# FORMER ELEMENTARY SITE PARK PLAN **CITY OF DETROIT, OREGON**

SEPTEMBER, 2013

Community  
Planning  
Workshop

Figure 1 2.2. Organic concept poster

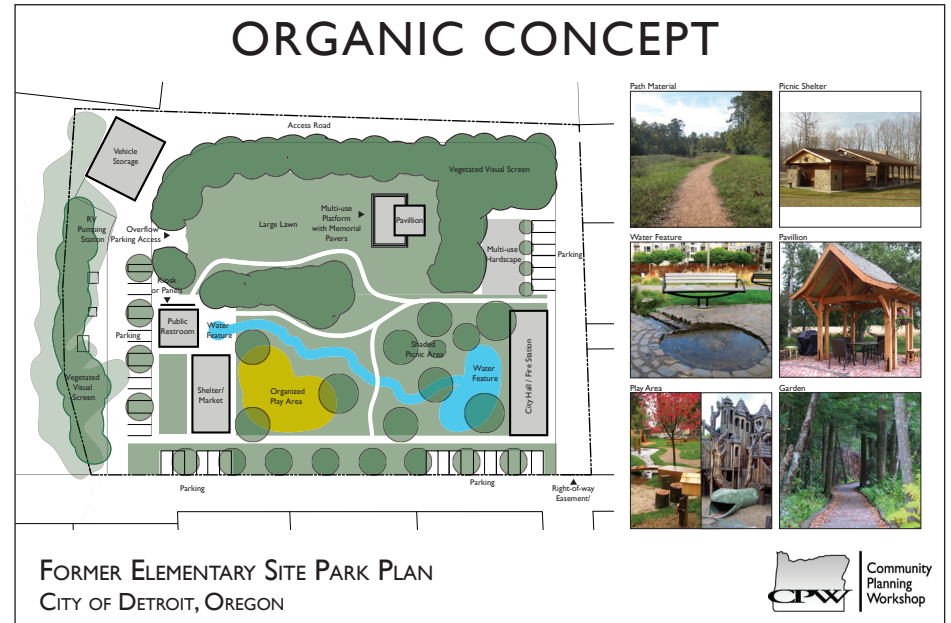
- Organic play area building is scary!
- Plaza is too urban feeling.
- Who manages the RV pumping station? Do we need it?
- No RV dumping, please.
- Need electricity in pavilion.
- No sand in the play area—becomes kitty litter!
- Wood playground would not hold up to weather.
- Not the stone pavilion.

Figure 13. Conceptual plan drawing

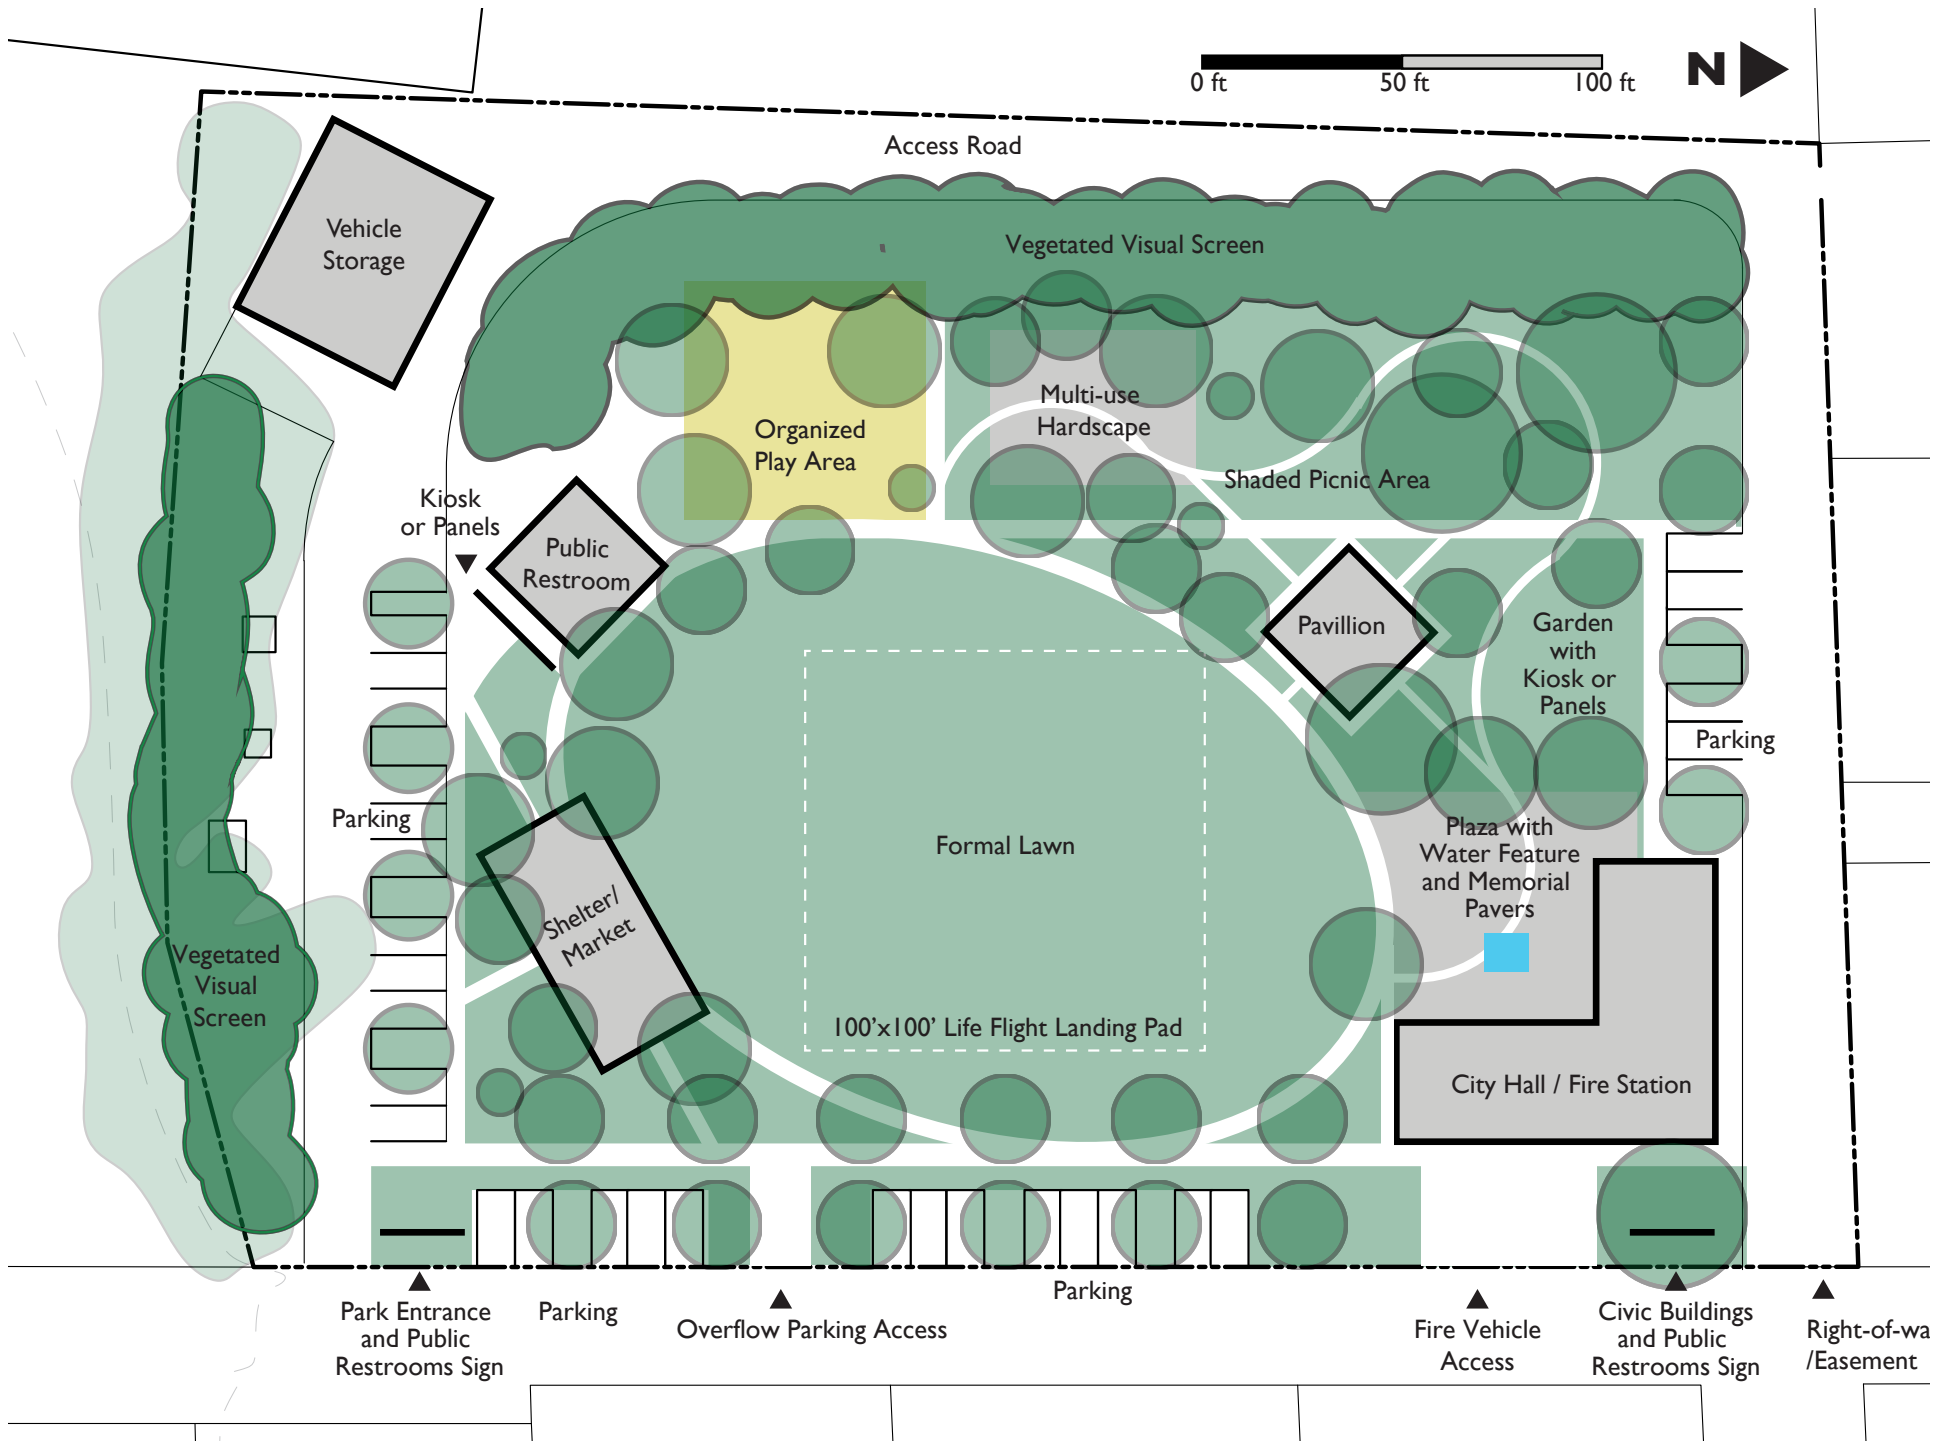
Both the Detroit Park Commission and City Council expressed overall satisfaction with the park design concept. CPW received the following feedback for changes or additions to the design and program:

- The multi-use hardscape element should include a basketball hoop.
- There should not be a separate skate-park element but the plaza should be designed to accommodate, not repel, skateboard users.
- Electrical outlets should be available throughout the site to accommodate community events.
- The location of the public restrooms should be moved to the southeast corner to most easily accommodate the needs of motorists. The location should be swapped with the location of the picnic/market shelter.
